Re: 230434 – Wallaroo Solar Farm

Appendix A - Response to item 1 – Planting Density

Appendix B Response to item 2 - Jarramlee Reserve buffer

Appendix C Response to item 3 – BESS locations

Conceptual landscaping plan

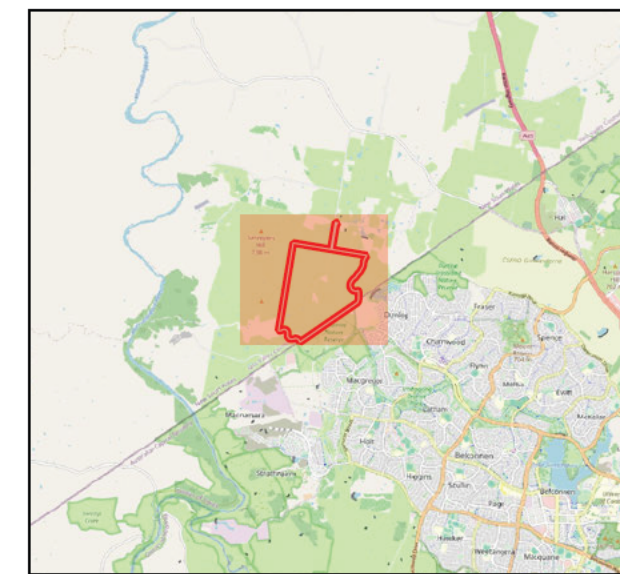
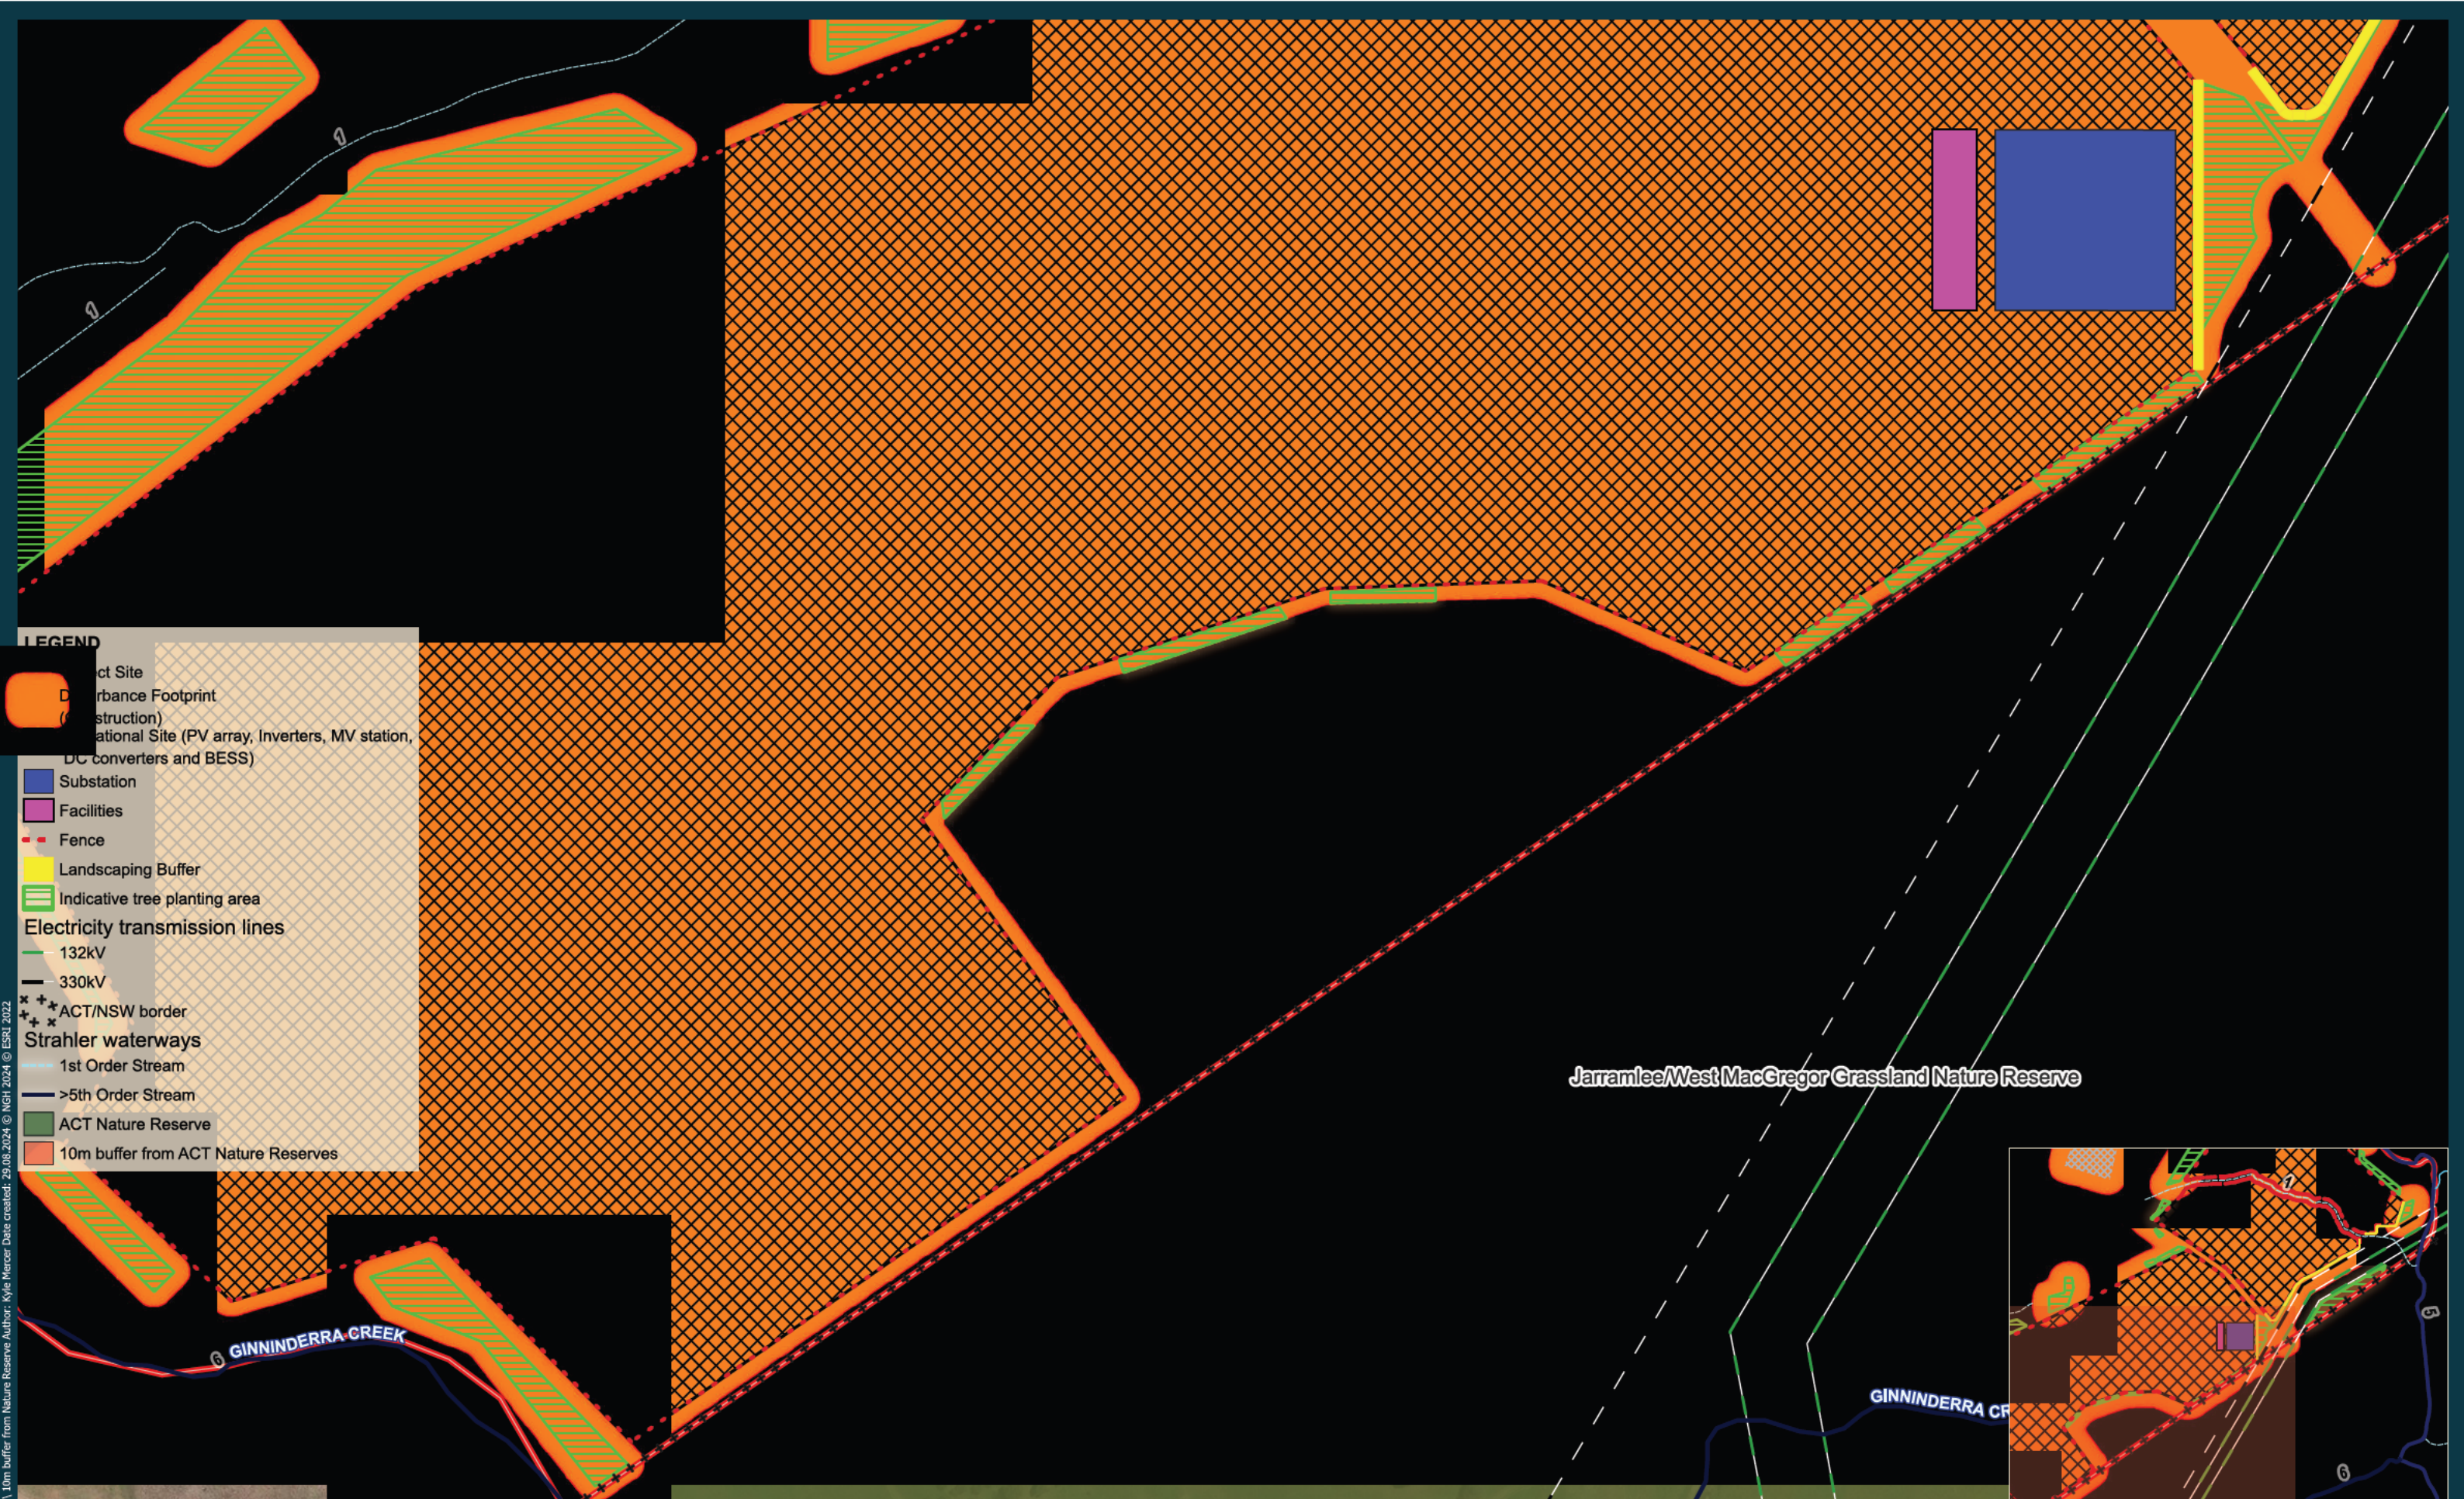
1. The IPC raised concerns about the density of planting from the PM02 photo point in the Visual Impact Assessment
2. The IPC requested confirmation that there is a 10m buffer from the Jarramlee Reserve and the Development footprint
3. The IPC asked if the indicative locations of the BESS can be shown in a map

In response to the IPCs request, both denser tree plantings and showing more mature growth have been modelled as per the following photomontages.

Whilst sparser plantings were originally proposed, Wallaroo Solar Farm will now commit to providing denser plantings. The spacing between the tree planting still provides the achieved effect sought for the the savannah woodland appearance areas, whilst avoiding an unnatural perimeter ring of plantings.
